## **Town of Arlington, MA Redevelopment Board**

### **Agenda & Meeting Notice July 22, 2019**

#### **1. Environmental Design Review, 1207-1211 Massachusetts Avenue, Arlington, MA - Docket #3602 Public Hearing**

# SPECIAL PERMIT - SITE PLAN REVIEW

3:00 PM

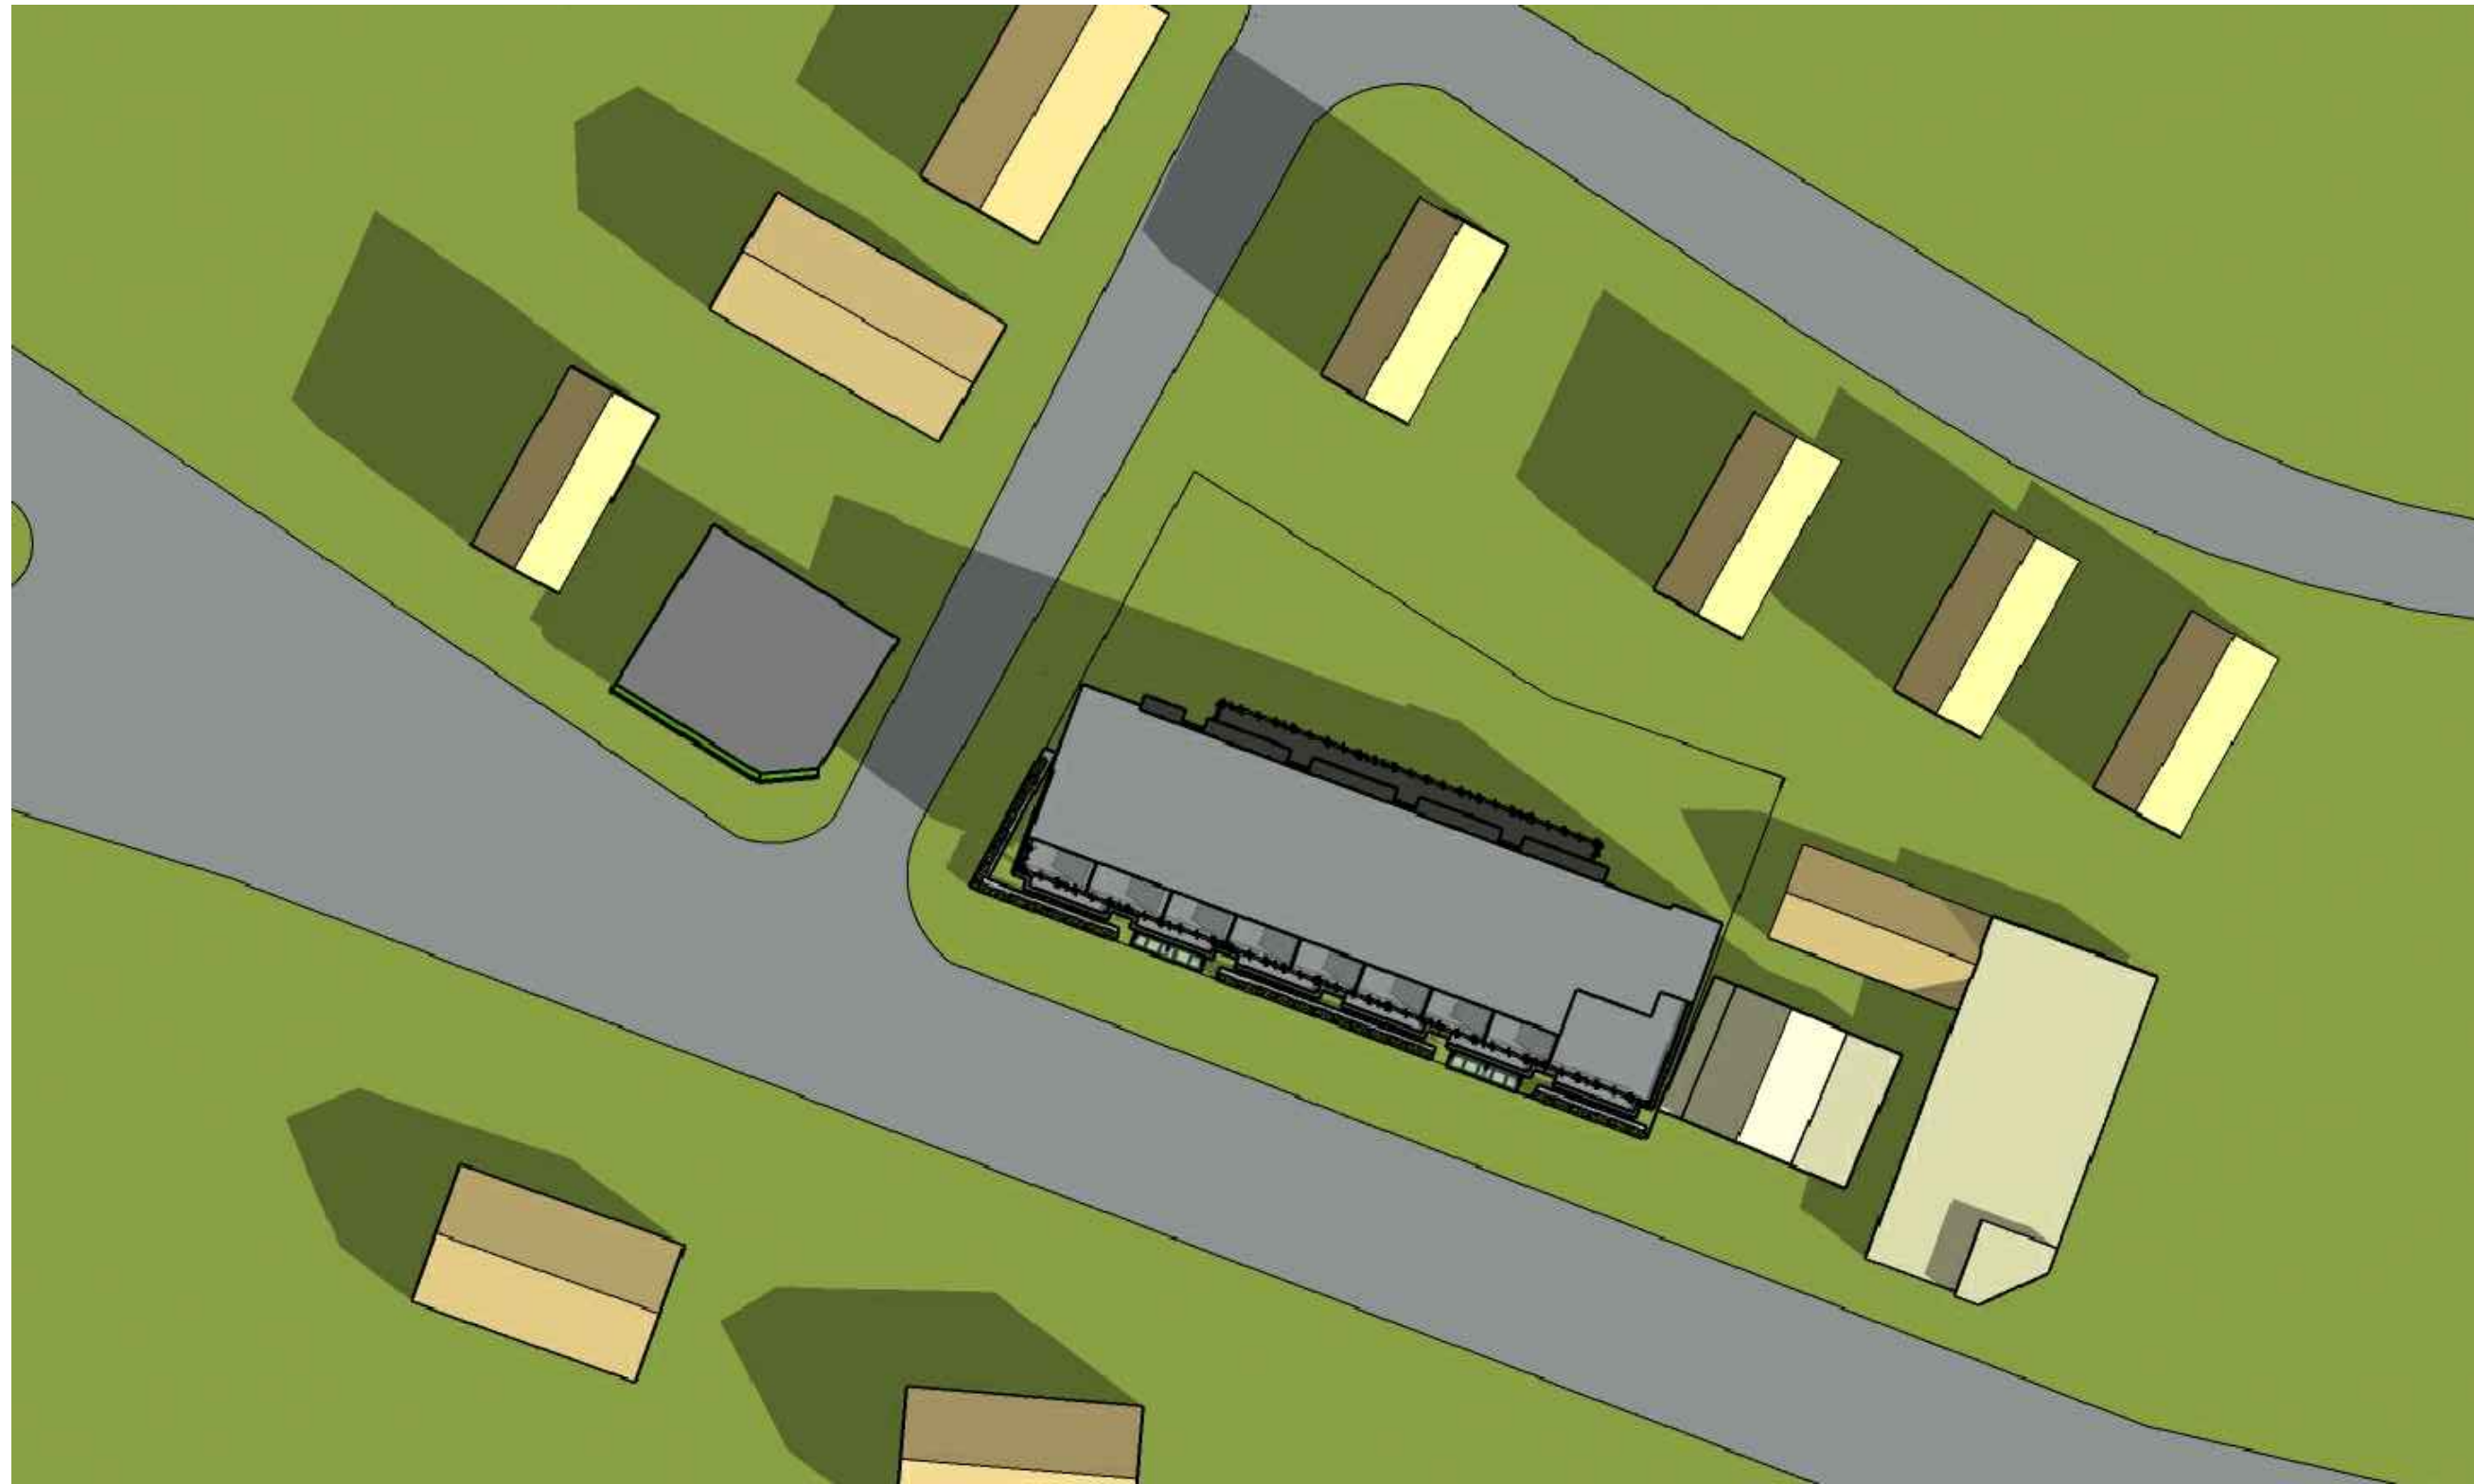
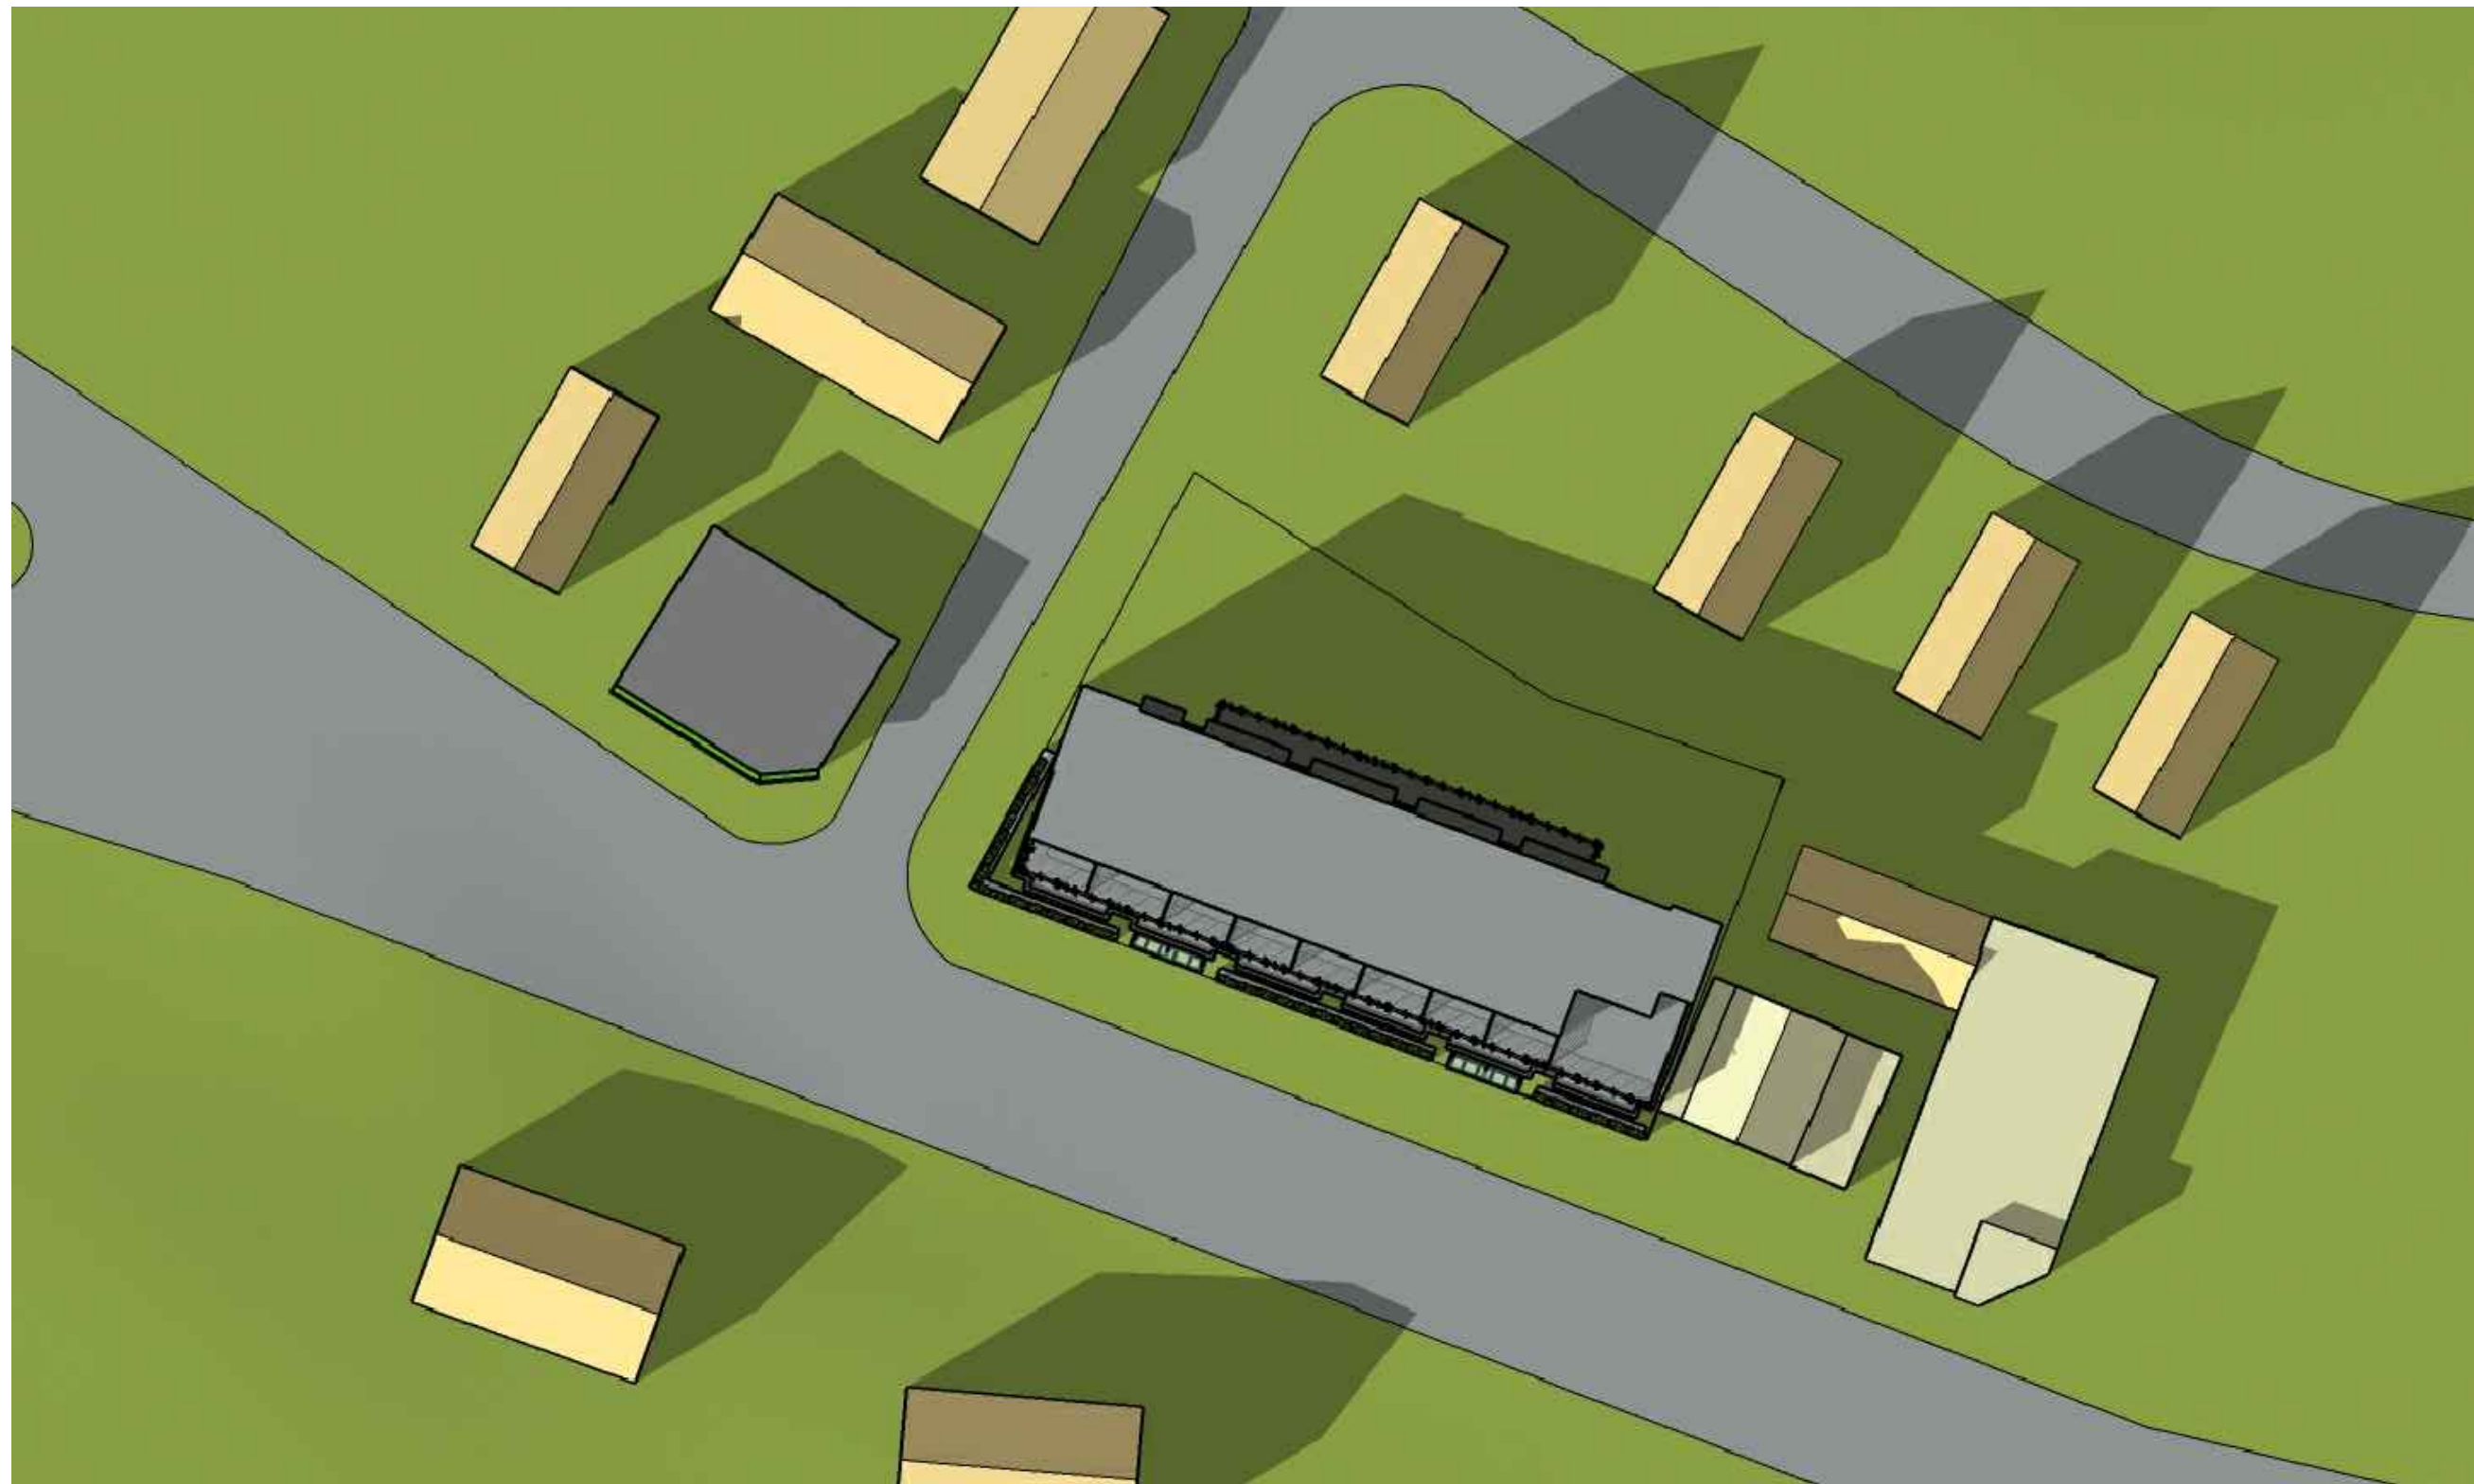
The building does not trigger the height buffer area of Section 5.3.19 because it is proposed at the lower maximum stories and height as identified in the Table of Dimensional and Density Requirements for the Business Districts. However, the application materials also provide a shadow study during each season at the respective Solstice and Equinox.

The proposed changes do not appear to significantly affect the immediate microclimate, however, the height of the new building may create shadows on adjacent residences, and the proximity of Mill Brook should raise questions about additional stormwater inputs and flooding impacts.
